ASSESSMENT REPORT

BULGA UNDERGROUND MINE Blakefield North Modification (DA 376-8-2003 Mod 5)

Figure 5 – Noise-affected receivers

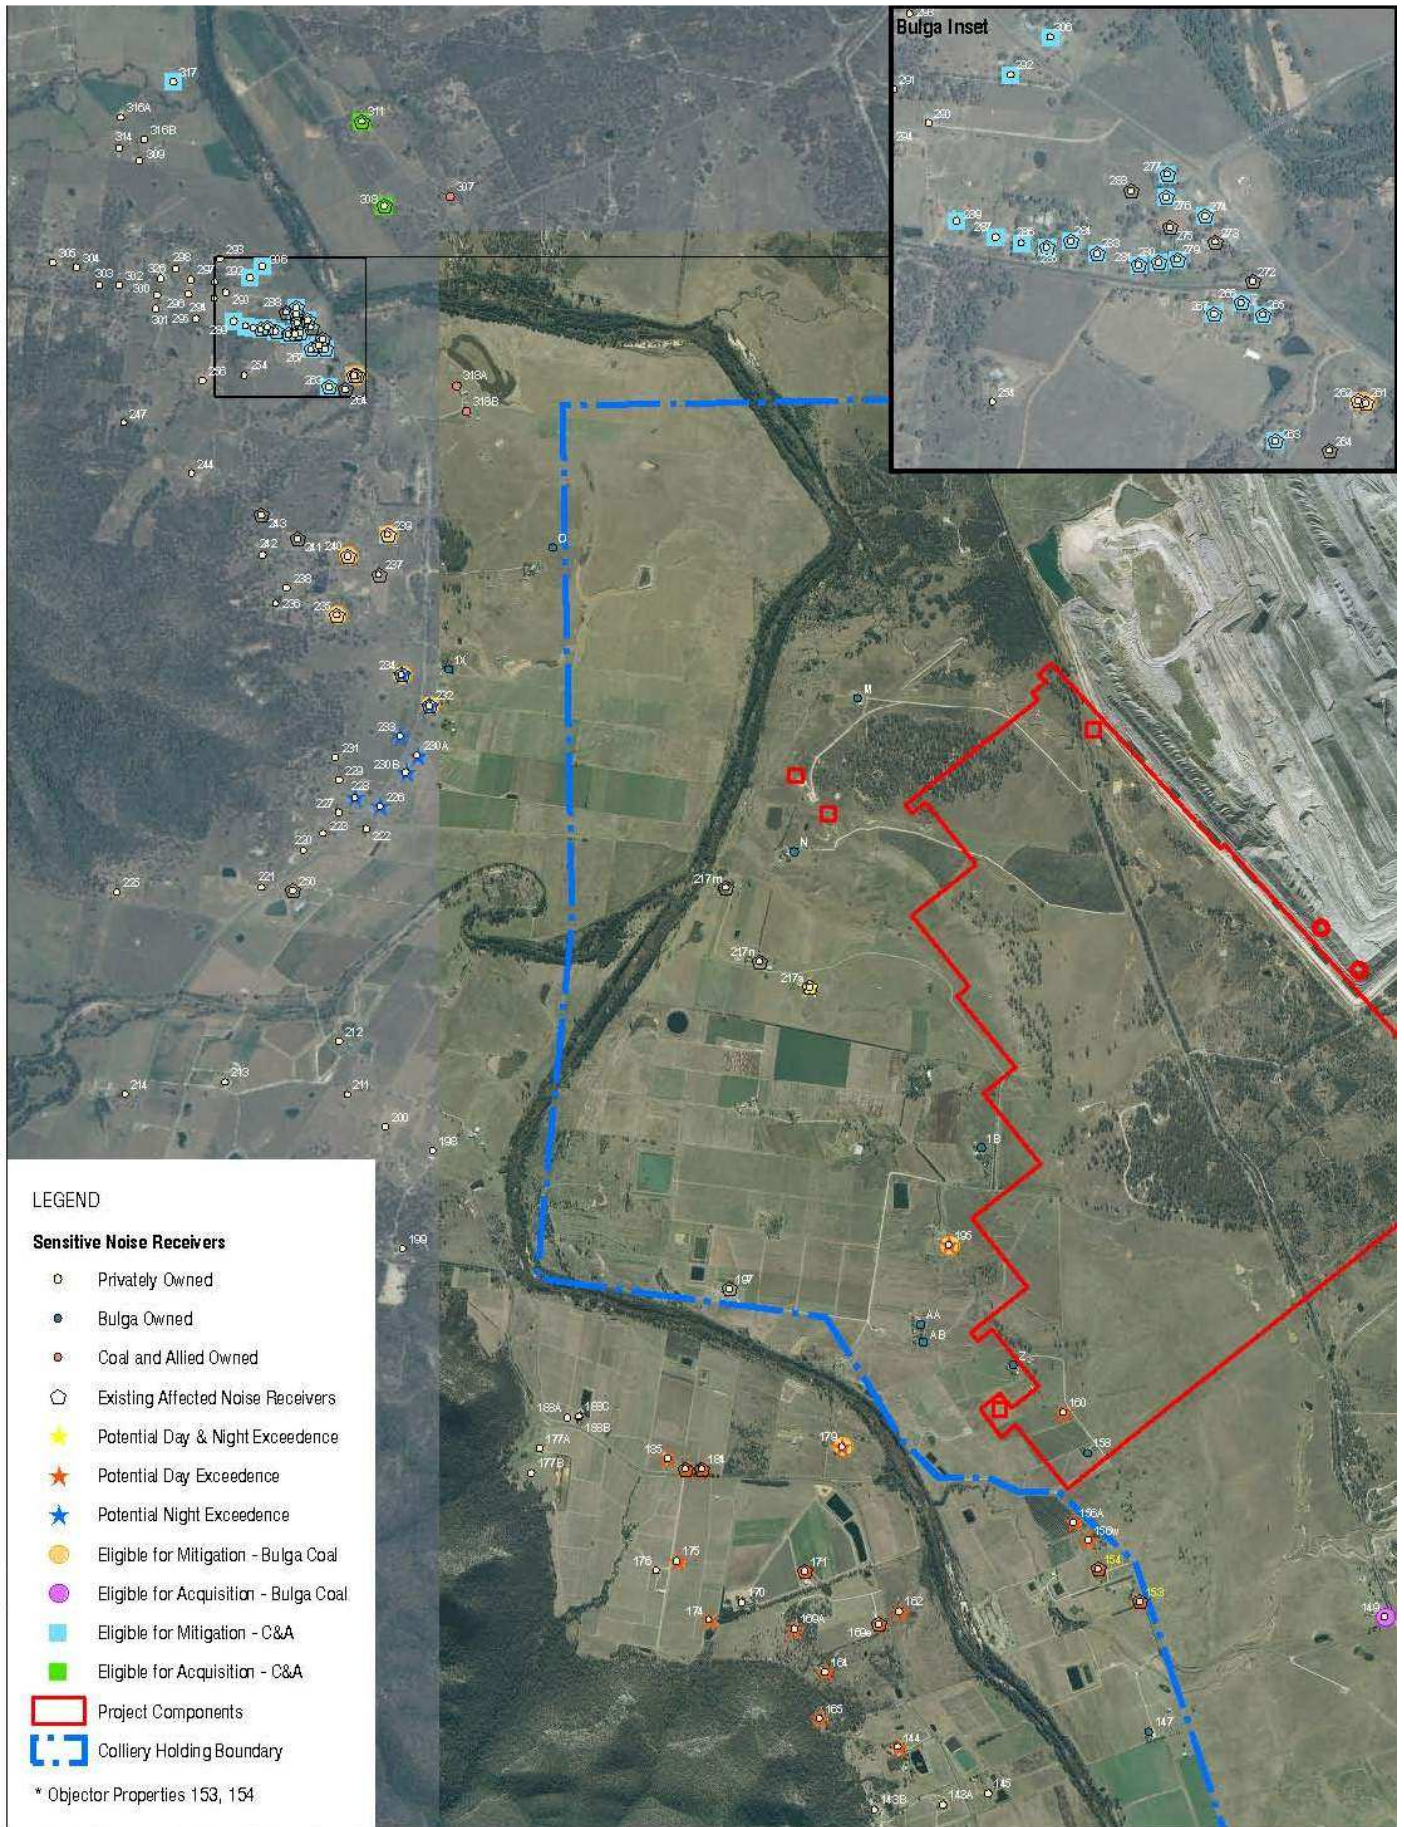
For receiver 160, which is the worst-affected of the day affected receivers owing to its location above the southwestern end of Longwall 1 and its consequent close proximity to a number of wells, predicted noise levels are above the operational noise limits on intermittent days in 5 distinct periods of approximately:

All 19 other day affected receivers are exposed to fewer gas well locations, including the objector's property (receivers 153 and 154), which is located well south of the southwestern end of Longwall 1. Receiver 154 (the nearer of the two) is some 850 m south of receiver 160.

There are no day time noise predictions that exceed the 'highly noise affected' threshold in the ICNG, which is 75 dB $L_{Aeq\ 15\ min}$. The predicted noise level at the worst affected receiver (number 160) is up to a maximum of 67 dB $L_{Aeq\ 15\ min}$ for a short period during the installation of goaf well number P1_16, which is less than 150 m away. The predicted noise levels at all other receivers, including the requisite 5 dB(A) modifying factor adjustment for low frequency noise where necessary, are 50 dB $L_{Aeq\ 15\ min}$ or less (usually much less). At this level, the noise predictions are comparable to the existing experience of day time noise in the locality. Day time median readings at nearby noise monitors are 45 dB to 51 dB $L_{Aeq\ 11\ hour}$, while the INP specifies an acceptable amenity criterion for rural residences of 50 dB $L_{Aeq\ period}$.

However, one SIS well (SIS 40), located to the northwest of Longwall 7, is close enough to nearby receivers that noise levels are predicted to exceed the evening/night *operational* noise limits at 9 “night affected receivers”. The predicted exceedances:

- are not more than 1 dB $L_{Aeq\ 15\ min}$ for 8 receivers, and 2 dB $L_{Aeq\ 15\ min}$ for receiver 217;
- are dominated by emissions from the open cut mine, which means the drilling noise would be difficult to discern;
- are up to 6 dB $L_{Aeq\ 1\ min}$ above the sleep disturbance limit at receiver 217 only;
- would occur only during southeast or east-south-east winds of up to 11 km/h for 8 receivers, and only during strong inversions for receiver 217; and
- would take place over a maximum period of 4 to 6 weeks.

- specify standard ICNG construction hours at those well sites where noise levels are predicted to exceed operational noise limits, except for drilling at SIS well 40;
- require notification to affected residents well in advance of any noise levels that are expected above operational noise limits; and
- require preparation of a Construction Noise Management Plan setting out a schedule for the construction work, reasonable and feasible noise mitigation, monitoring and a response protocol should there be isolated occasions where noise impacts are higher than predicted.

Figure 6 – Overlying Linear Surface Features

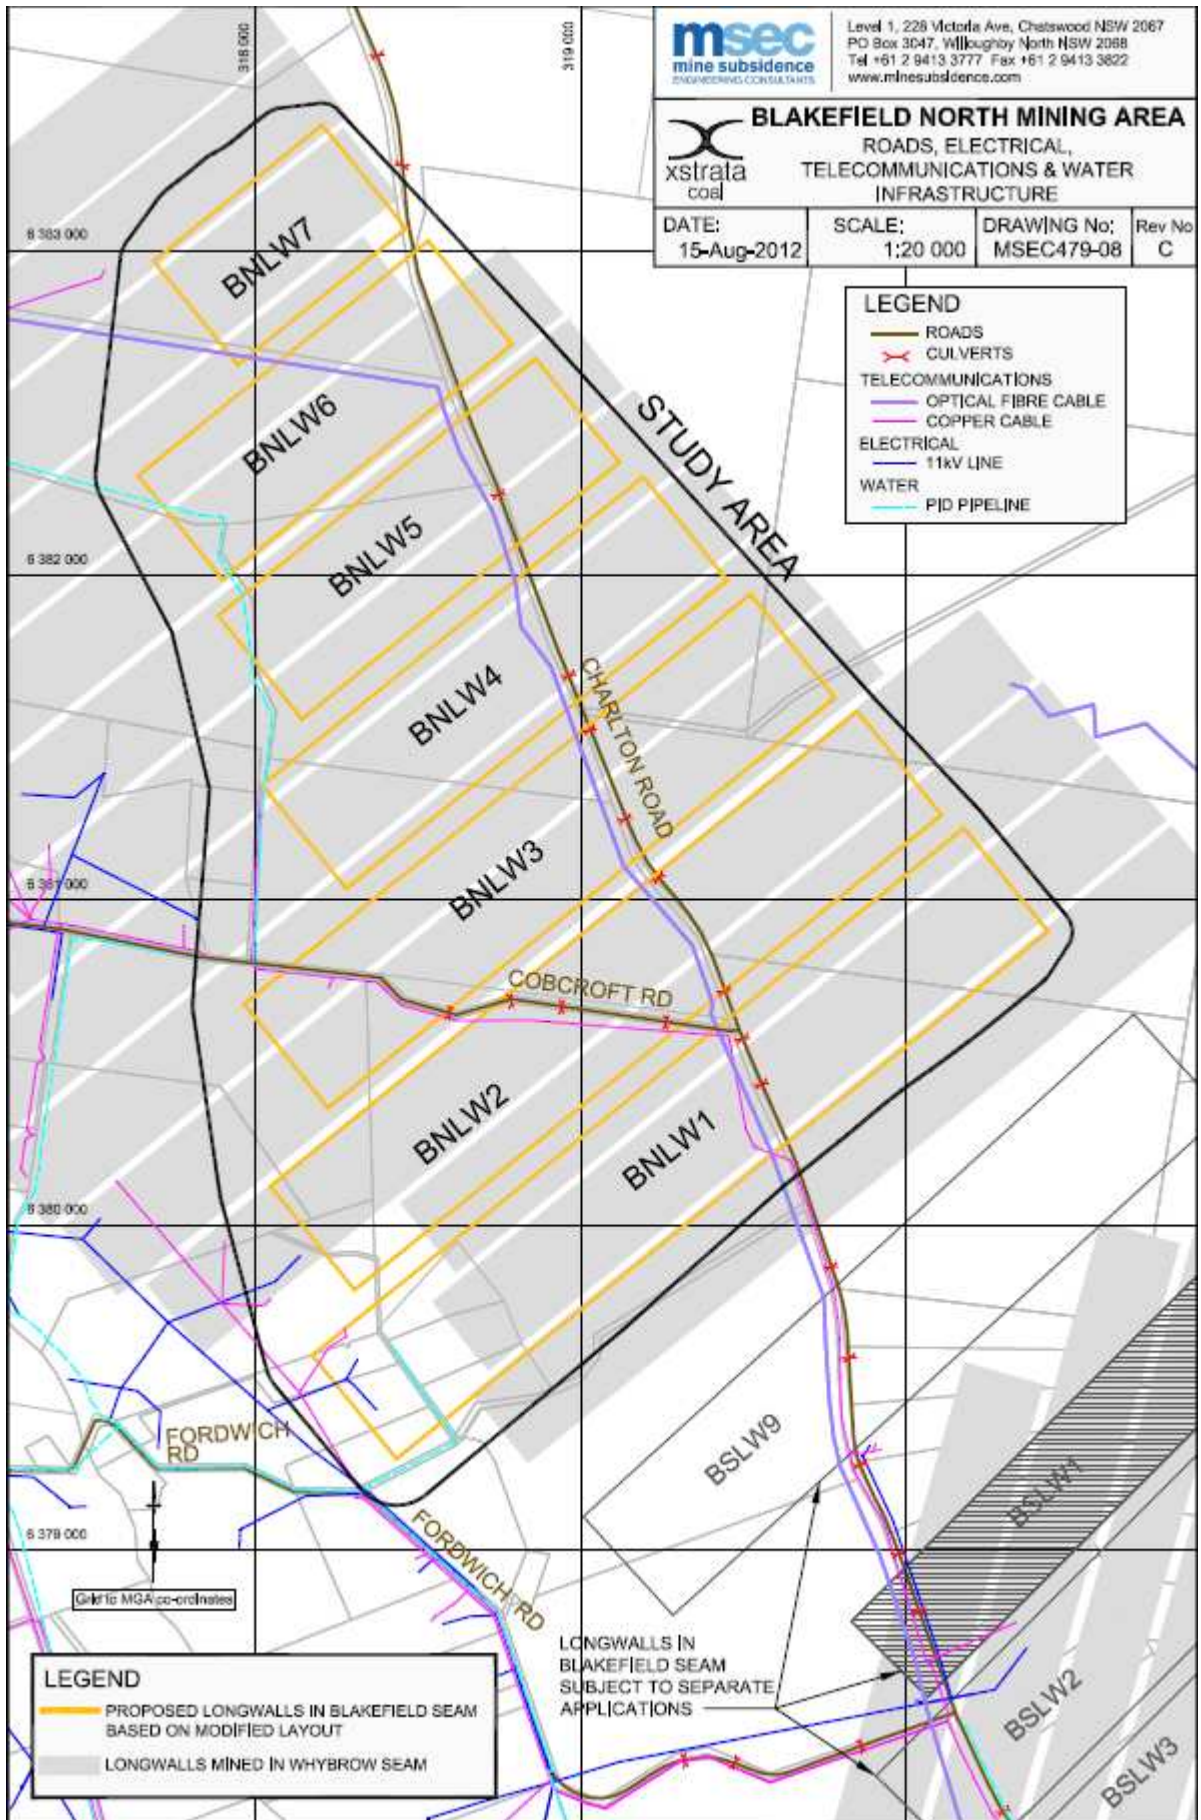
Charlton Road is a sealed Council road which follows the alignment of the Great North Road, which was a convict-era road connecting Sydney to the Hunter Valley. The alignment is historically significant in parts, although there is no NSW heritage listing for the section overlying the Blakefield North Mine. Cobcroft Road is also a sealed Council road, while Fordwich Road is an unsealed Council road. These roads and the associated road drains would undergo the full range of predicted subsidence; resulting in troughs, ponding, compression heaving and cracking, which could affect public safety and serviceability.

However, the road formations are of flexible construction and these impacts would develop gradually, in time to be observed and repaired using normal road repair methods. Charlton Road, in particular, has been previously subsided without mishap both during the single seam Beltana No 1 operation and the multi-seam Blakefield South operation. Bulga would visually monitor and inspect impacts as they occur and manage safety, serviceability and repairs in consultation with Council, according to its existing management strategy.

Telstra's fibre optic cable runs adjacent to Charlton Road and there are copper cables adjacent to both Charlton and Cobcroft Roads. These cables would experience the same range of subsidence effects as the roads and have also been previously subsided without incident under single and multi-seam mining at Beltana No 1 and Blakefield South. A duplicate of the fibre optic cable has already been installed inside a flexible duct adjacent to Charlton Road. This was a subsidence impact preventative measure before Beltana No 1 was extracted. It should withstand the additional subsidence if there is enough cable to draw at either end of the duct. Bulga would continue to manage subsidence impacts in consultation with Telstra and according to its existing management strategies.

A PID pipeline made of butt-welded polyethylene crosses the south-western end of proposed Longwalls 4, 5 and 6, and a smaller distribution line crosses proposed Longwall 3. The pipeline design was approved by the Mine Subsidence Board to withstand strains of at least 70 mm/m. This is more than the strains expected under the proposed modification. However, the MSEC report recommends the pipe should be uncovered and provided with a sand base directly above the ends of Longwalls 5 and 6 so that it is isolated from localised unconventional subsidence. Bulga has committed to do this. The pipeline has previously been subsided over the Beltana No 1 Mine and Bulga would continue to manage subsidence impacts according to its existing management strategies.

Figure 8 – Endangered Ecological Communities and Endangered Population habitat

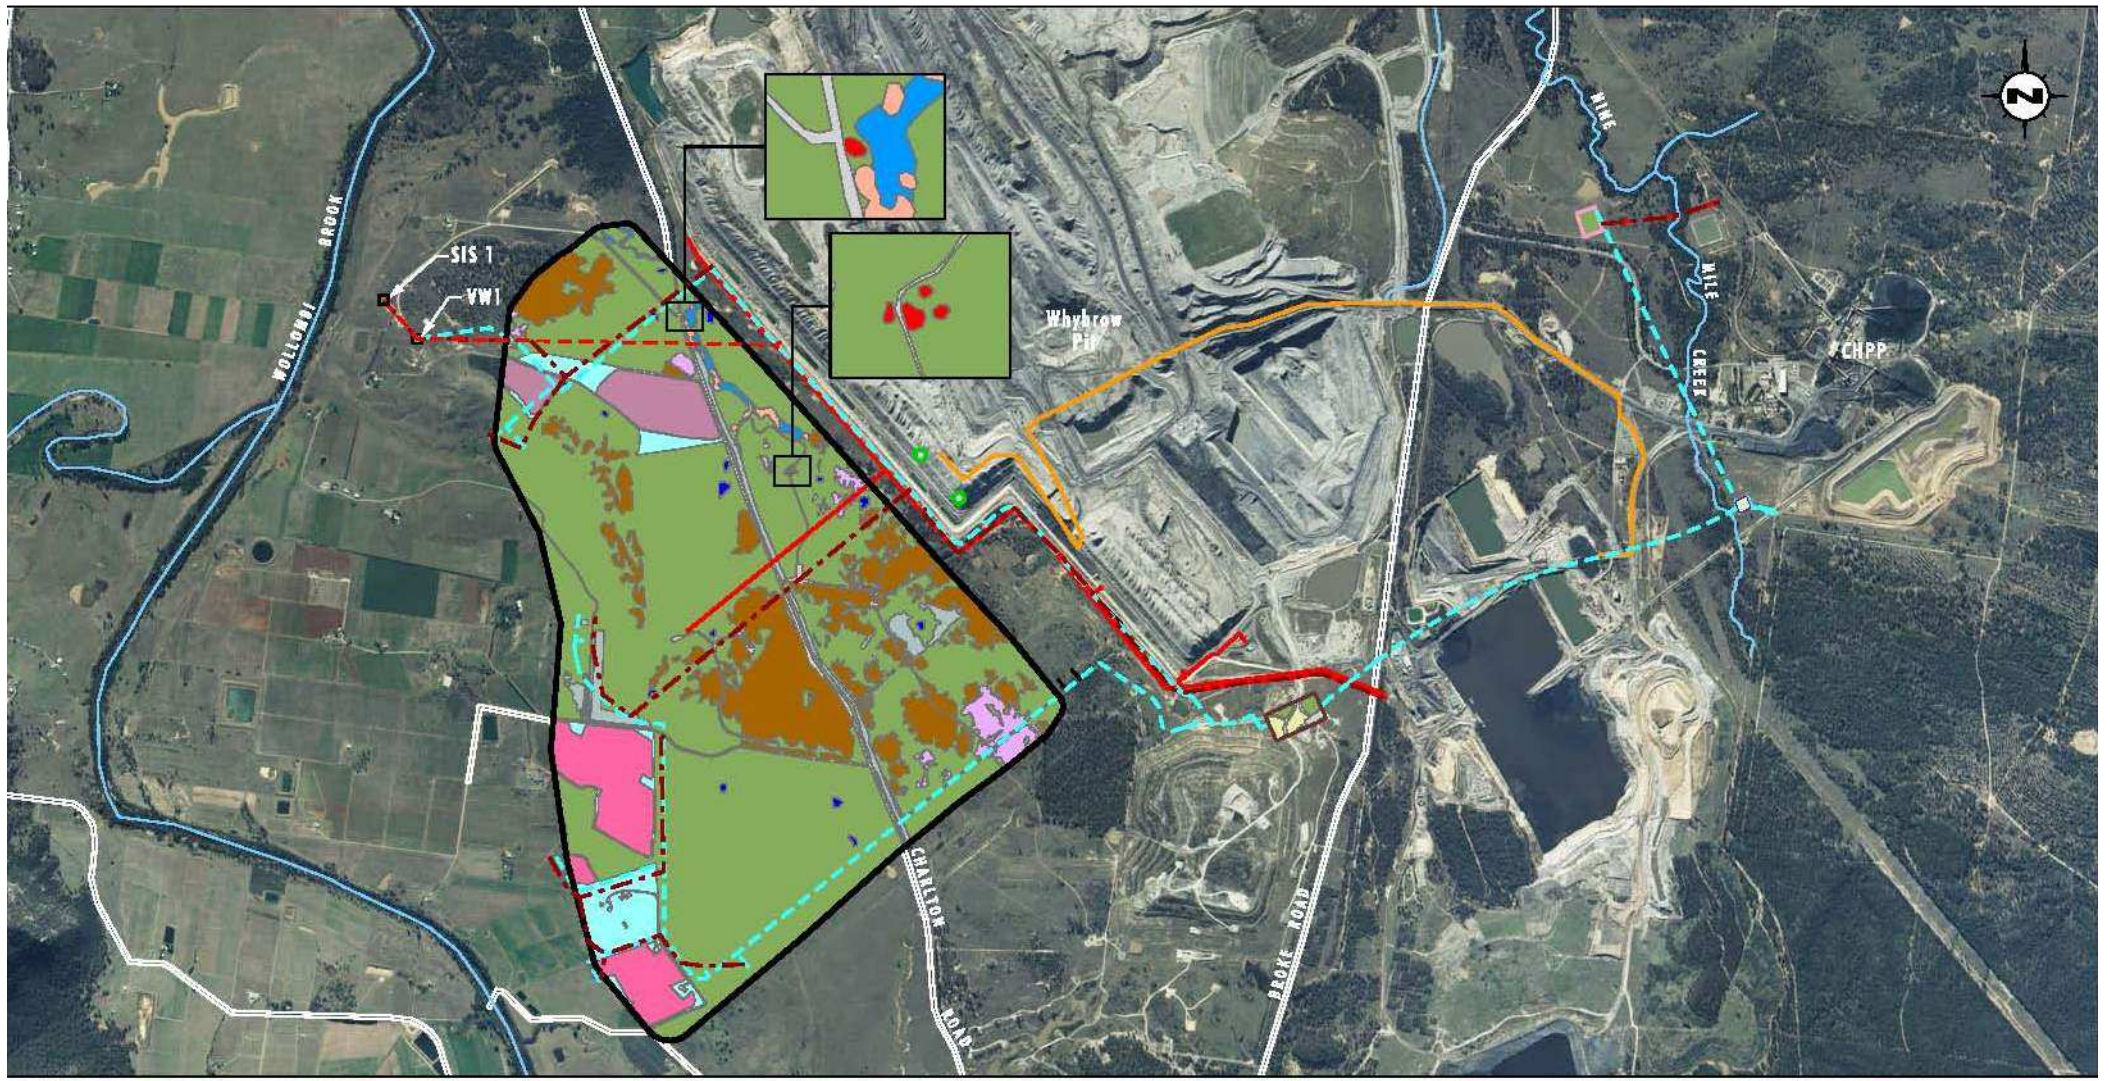
There are 2 Endangered Ecological Communities (EECs) and 1 Endangered Population within the subsidence area or the surface facilities areas, as follows (see **Figure 8**):

- 103 ha of *Central Hunter Grey Box – Iron Bark Woodland* EEC, of which approximately 5 ha would need to be cleared for the surface facilities;
- 0.15 ha of *Hunter Valley Weeping Myall Woodland* EEC; and
- 760 mature and 2050 juvenile individuals of Weeping Myall (*Acacia pendula*) which constitute an Endangered Population.

The proposal requires 5.34 ha of *Central Hunter Grey Box – Ironbark Woodland* EEC to be cleared and 23.71 ha of the associated derived native grassland. The proposal does not require any individual *Acacia pendula* to be cleared, either within the EEC or the broader Endangered Population.

The Department and the OEH both consider that Bulga's provision of an offset as part of the larger Reedy Valley offset is an acceptable and appropriate approach, given the small additional area of offset land involved in respect of this current modification. The Department has therefore included a condition in its recommended approval which requires Bulga to provide an offset for the 5.34 ha of EEC clearing and 23.71 ha of disturbance, to the satisfaction of the Director-General, by the end of December 2014.
